## Model: PE800020

### REPLACEMENT SOLDER POT ELEMENT

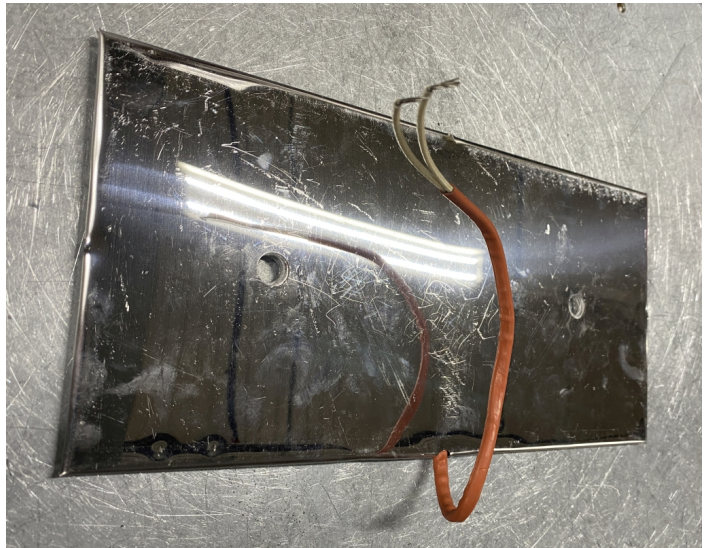
Our 1,200 Watt heating element for the Model 80T (The Swimming Pool) used to come with two tabs on the long side of the element. This required a set of jumpers to attach to the thermostat and cord-set. We have improved upon this design by hard-wiring high temperature connectors directly into the body of the heating element.
